Product Change Notice (PCN)

PCN Number: PCN-*045-1166R*-01

Product(s) Affected: *PJ-042*

PREVIOUS CUI DEVICES DETAIL / IMAGE	NEW CUI DEVICES DETAIL / IMAGE

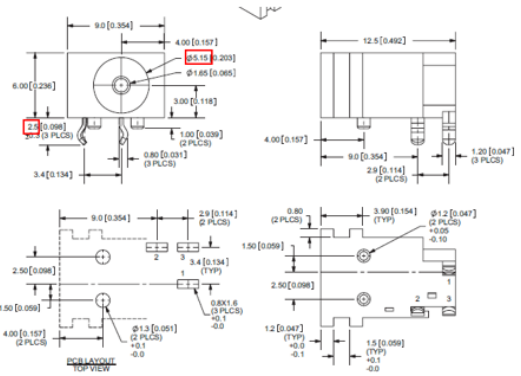
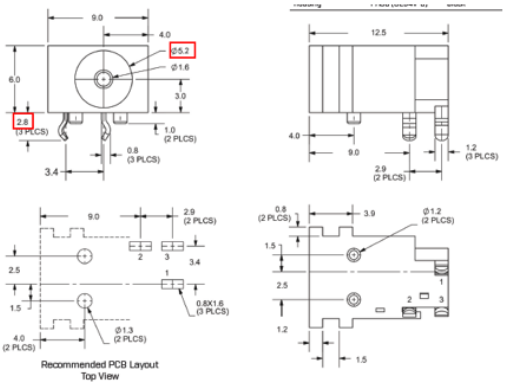
Description of Change: *Minor Structural and material Difference. See image Below*

MATERIAL	PLATING
center pin	brass	tin
terminal 1	brass	tin
terminal 2	copper alloy	tin
terminal 3	brass	tin
plastic	PA66

DESCRIPTION	MATERIAL	PLATING/COLOR
center pin	brass	tin
terminal 1	brass	tin
terminal 2	phosphor bronze t=0.3	tin
terminal 3	brass t=0.3	tin
housing	PA66 (UL94V-0)	black

MATING PLUG
Jack Insertion Depth: 8.00 mm

MATING PLUG
Jack Insertion Depth: 7.8 mm
